Intel[®] Pentium[®] III Xeon[™] Processor Specification Update

Release Date: September 2000

Order Number: 244460-020

The Pentium[®] III Xeon processor may contain design defects or errors known as errata which may cause the product to deviate from published specifications. Current characterized errata are documented in this Specification Update.

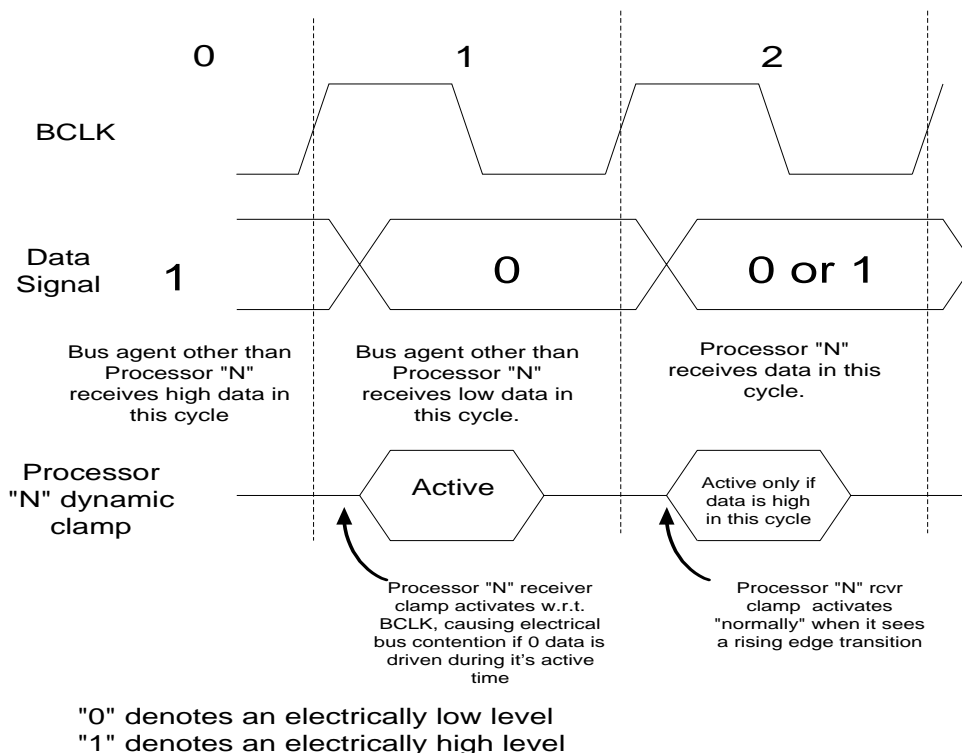
Workaround: The AGTL+ V_{REF} (input voltage reference) level will be raised from 1.0V to 1.1V (assuming a V_{TT} of 1.5V) on the processor cartridge substrate. This allows the dynamic clamp to activate at a trigger level approximately 100 mV higher than with the previous 1.0V V_{REF} setting. Due to the dependence upon system bus design, bus layout may be evaluated to determine the need for improvements in falling edge ringback levels. This may involve one or several of the following baseboard modifications:

1. Change termination resistor value to reduce multi-bit noise and/or improve V_{IL} noise margin.
2. Reduce multi-bit noise by improving ground return paths (additional high-frequency decoupling, improved AC plane referencing, etc.).
3. Raising or lowering the V_{TT} level (within the AC & DC tolerances specified in the processor EMTS) to improve V_{IL} noise margin and/or reduce the multi-bit noise due to dl/dt transients.

Stress tests using various data patterns and transactions should be run to identify the worst-case multi-bit noise conditions for this erratum.
